**NEBRASKA ARMY NATIONAL GUARD
1776 READINESS CENTER
DEDICATED OUTSIDE AIR SYSTEM (DOAS)**
at the

PROJECT NO. 31030365

A D D E N D U M N O . 1

DRAWING TITLE:
POWER/LIGHTING – BASEMENT
FLOOR PLAN

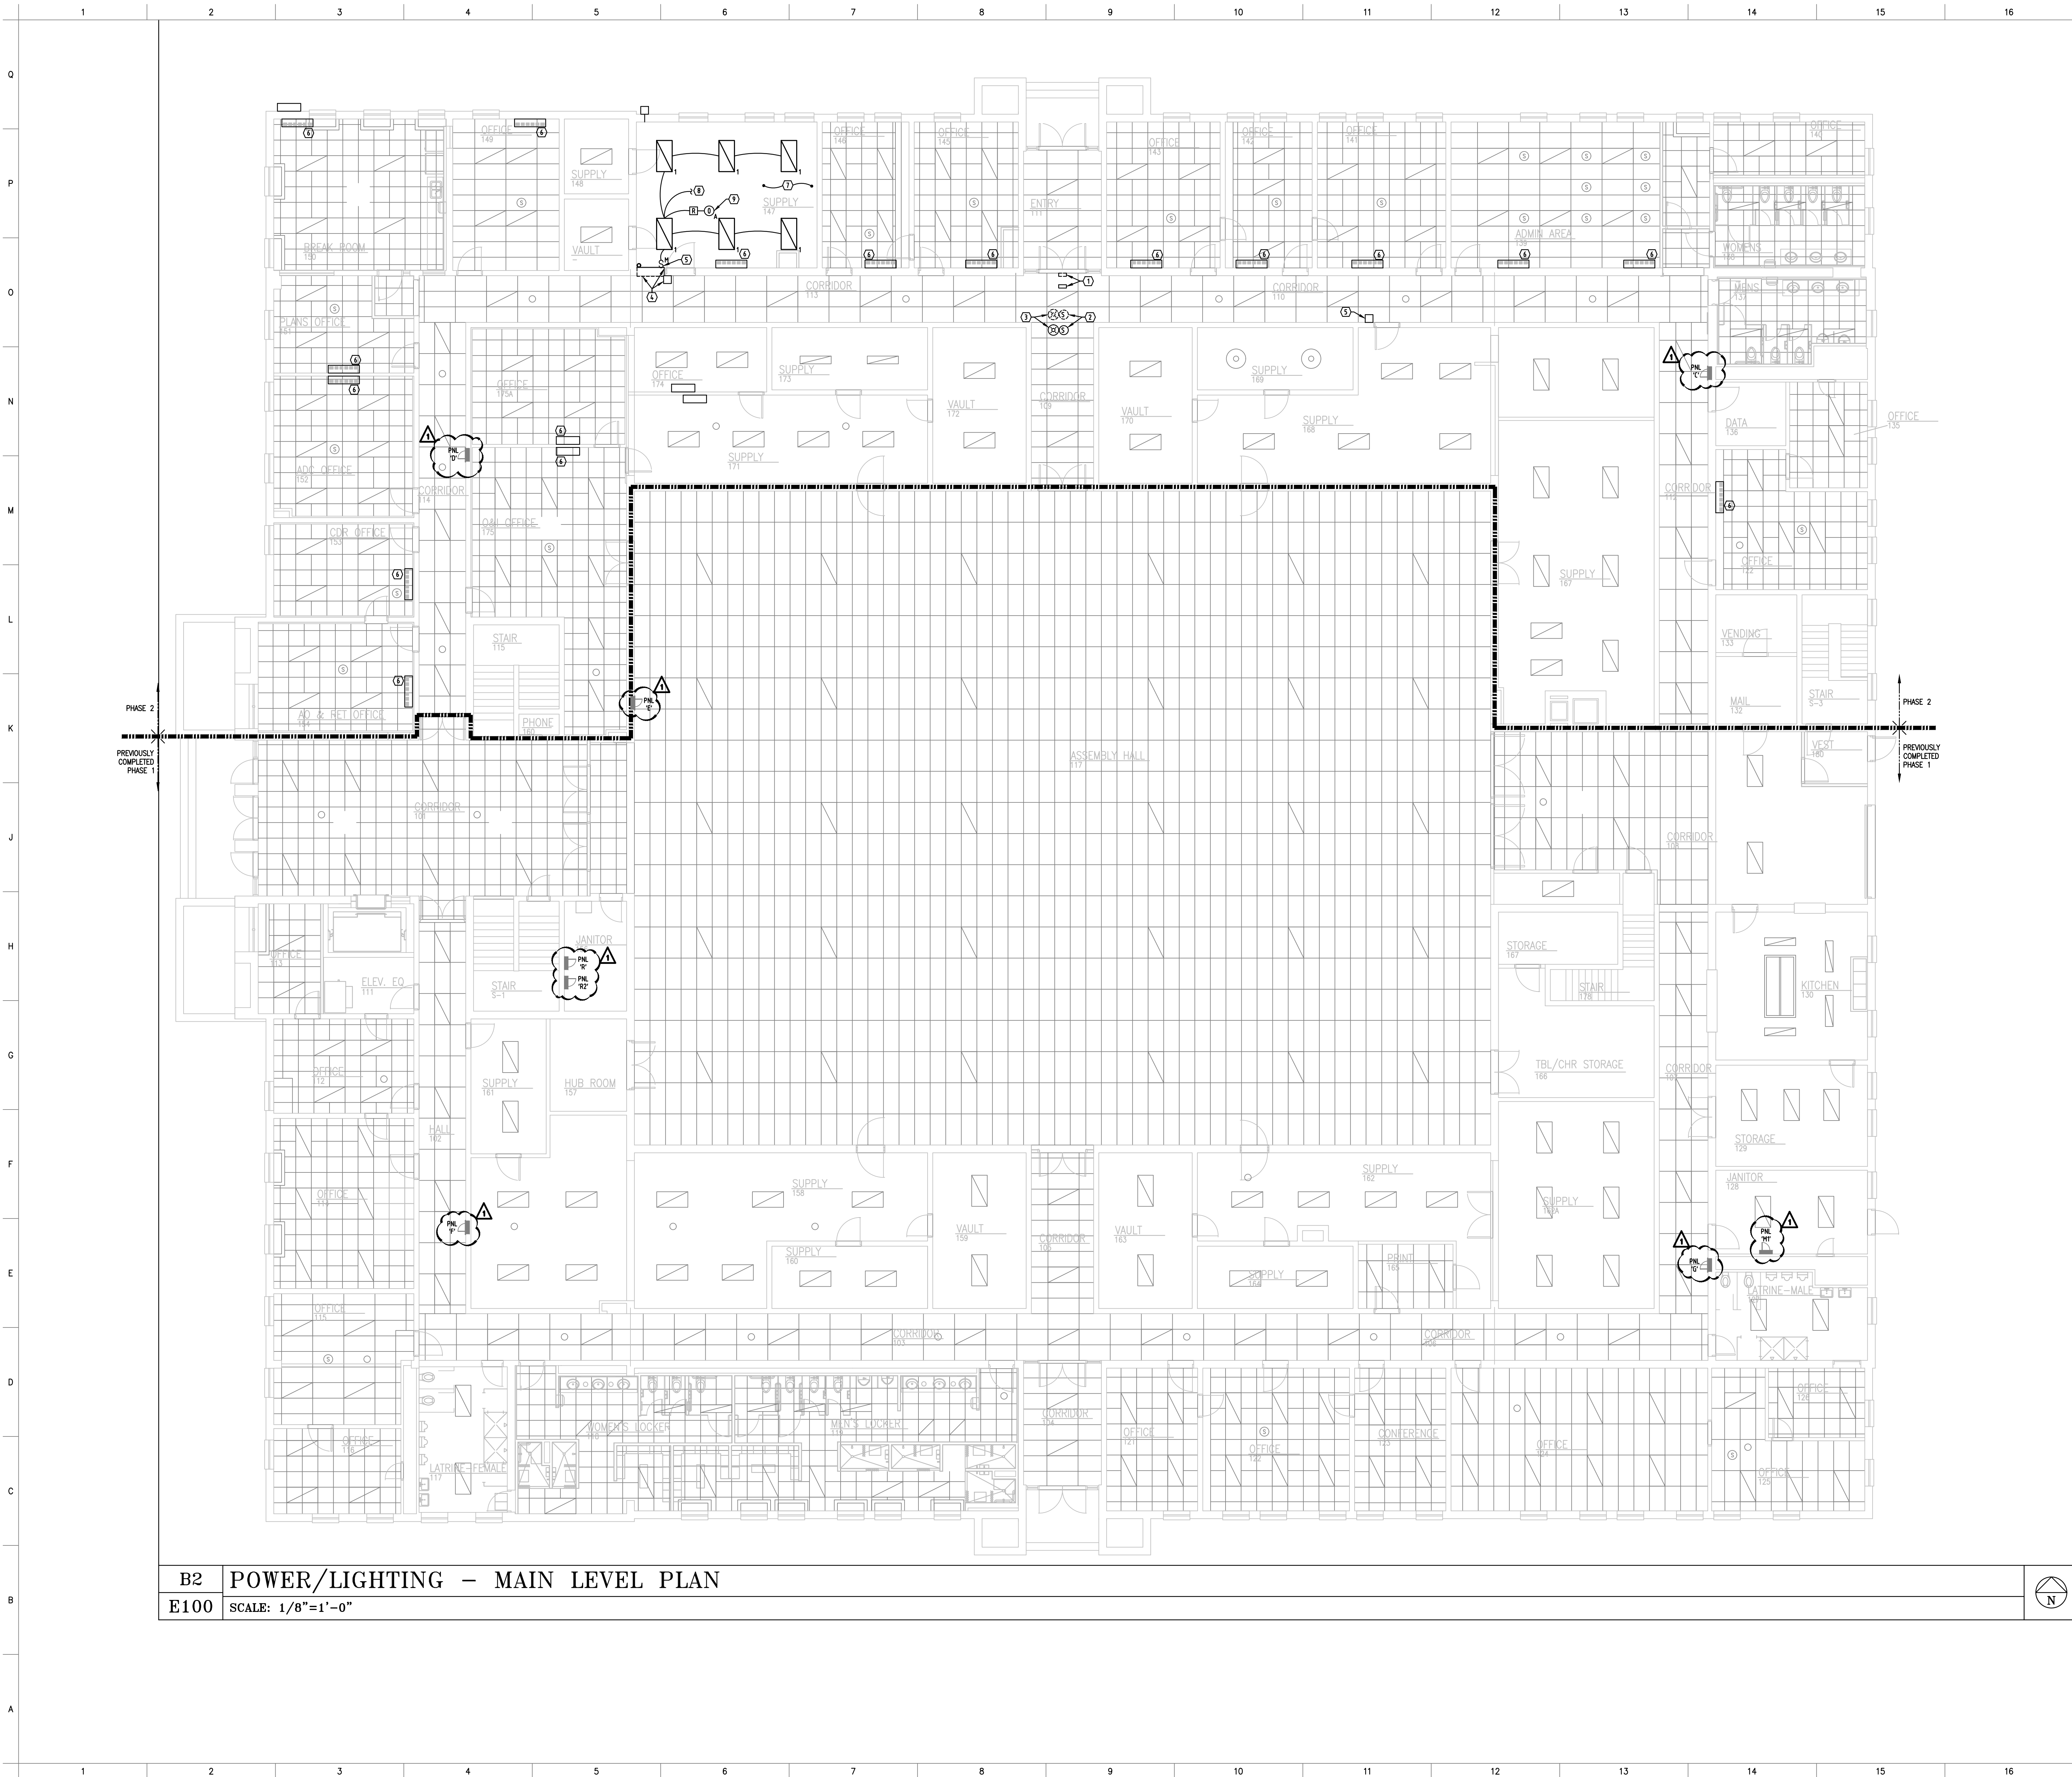
- ADD 1-11 Reference Sheets E000, E100, E200, and E400
1. See attached revised sheets indicating known locations of existing electrical panels. Electrical panels are shown for reference for demolition of existing electrical and installation of new equipment. See attachment #6.
- ADD 1-12 Reference Sheet E300
1. Detail B2, Power - Roof Plan, NW Corner of Roof
 - a. Add – Disconnect conductors from existing exhaust fan and at circuit panel. Remove conductors. Abandon conduits in place, label at each end with tape "Abandoned". See attachment #4.
